The Commission has issued the enclosed Amendment Nos. 58 and 50 to Facility Operating Licenses Nos. DPR-42 and DPR-60 for the Prairie Island Nuclear Generating Plant, Unit Nos. 1 and 2, respectively in response to your application dated June 14, 1982.

The amendments revise the Appendix A Technical Specifications concerned with the peak burnup limits shown in Figure TS 3.10-7. The peak burnup limit is increased from 41,850 to 47,000 MWD/MTU.

PRAIRIE ISLAND NUCLEAR GENERATING PLANT UNIT NO. 1

SAFETY EVALUATION BY THE OFFICE OF NUCLEAR REACTOR REGULATION
RELATED TO AMENDMENT NO. 56 TO FACILITY OPERATING LICENSE NO. DPR-42
AND AMENDMENT NO. 50 TO FACILITY OPERATING LICENSE NO. DPR-60
NORTHERN STATES POWER COMPANY
PRAIRIE ISLAND NUCLEAR GENERATING PLANT, UNIT NOS. 1 AND 2
DOCKET NOS. 50-282 AND 50-306

Fig. TS.3.10-7

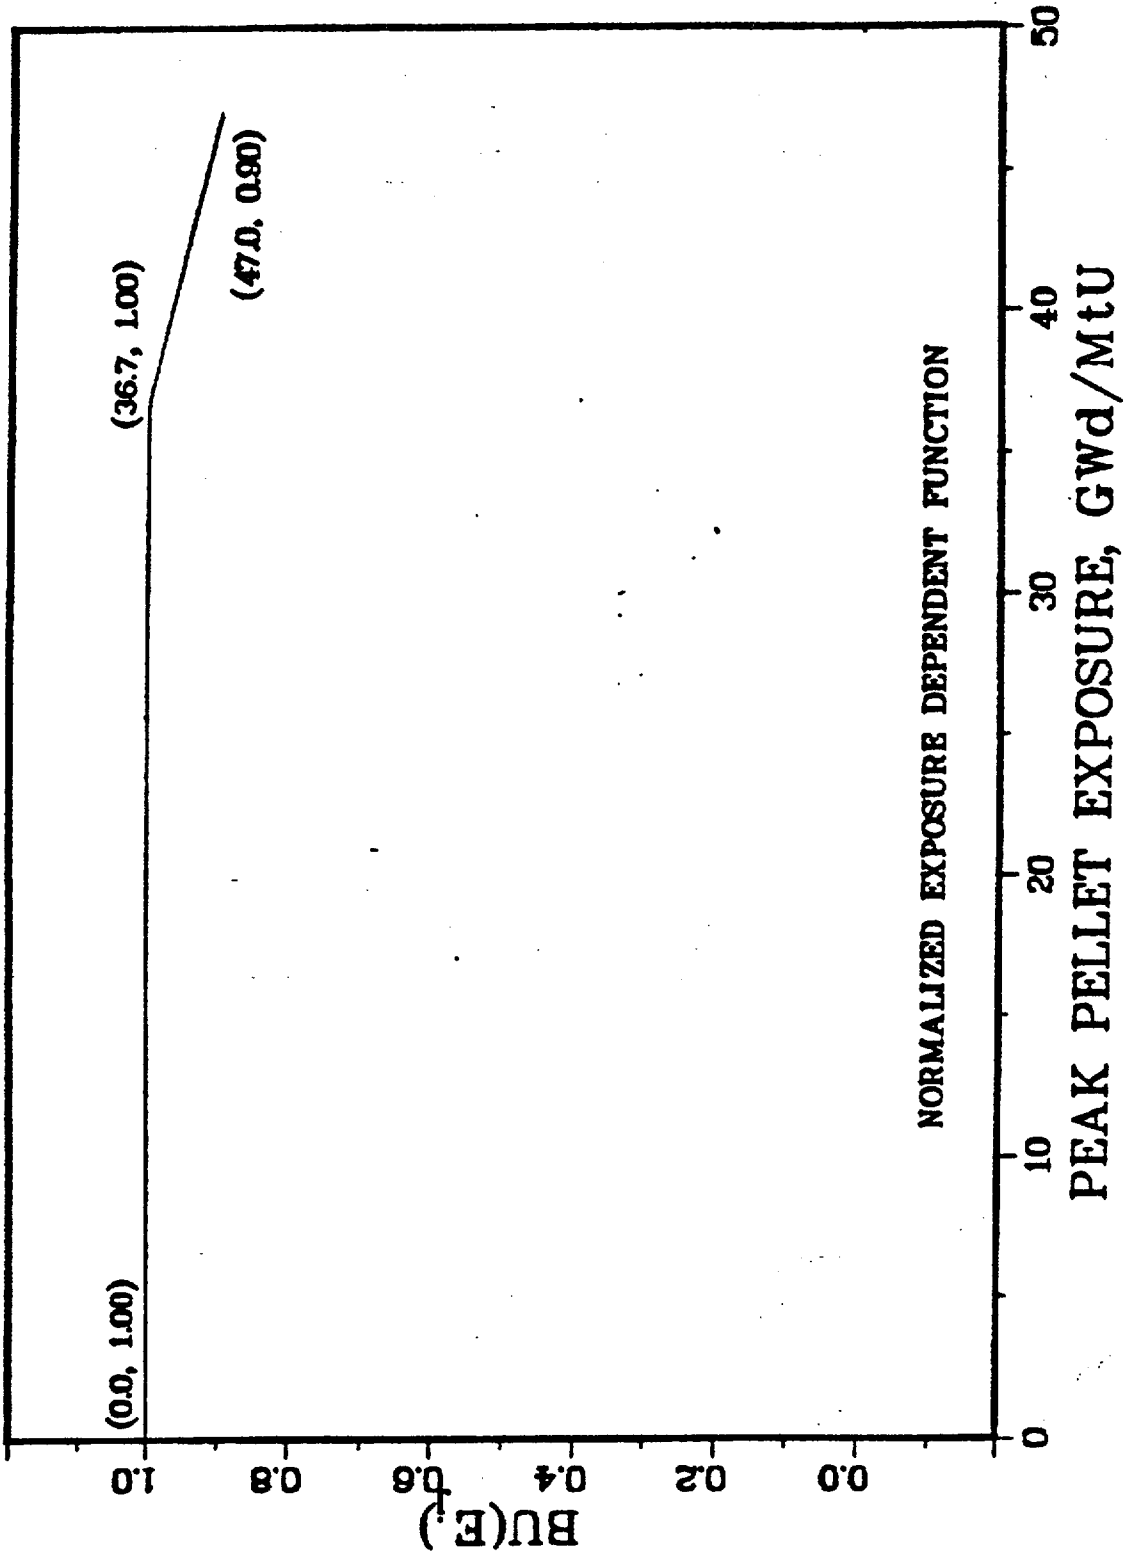
We have examined the licensee's request for an extension of the exposure-dependent power peaking factor at Prairie Island Unit Nos. 1 and 2. The licensee's proposed Figure TS.3.10-7 allows a peak pellet exposure to 50,000 MWd/MtU. However, our review is based on the licensee's documentation supporting operation to 47,000 MWd/MtU. On this basis we find the proposed change acceptable for both Units to a peak pellet exposure of 47,000 MWd/MtU, as shown in the revised Figure TS 3.10-7. The revision to the Figure TS 3.10-7 was discussed with and agreed to by the licensee.

The amendments revise the Appendix A Technical Specifications concerned with the peak burnup limits shown in Figure TS.3.10-7. The peak burnup limit is increased from 41,850 to 47,000 MWD/MTU.

The F_Q limit developed by Exxon (Ref. 2) for this submittal (the third curve) has been determined for peak pellet exposures of up to 47,000 MWd/MtU. Assuming a peaking factor of 1.3, this exposure corresponds to a batch average discharge burnup of 36,000 MWd/MtU. We note that batch average discharge burnups of 35,700 and 36,100 MWd/MtU have been achieved for Unit 1 Cycle 5 and Unit 2 Cycle 3 fuel, respectively. An exposure dependent function, as required for the Prairie Island Technical Specifications, is shown in Figure 1. This exposure dependent function is based on the third curve rather than the fourth curve. Analyses to support further extensions of this function were not submitted by the licensee.
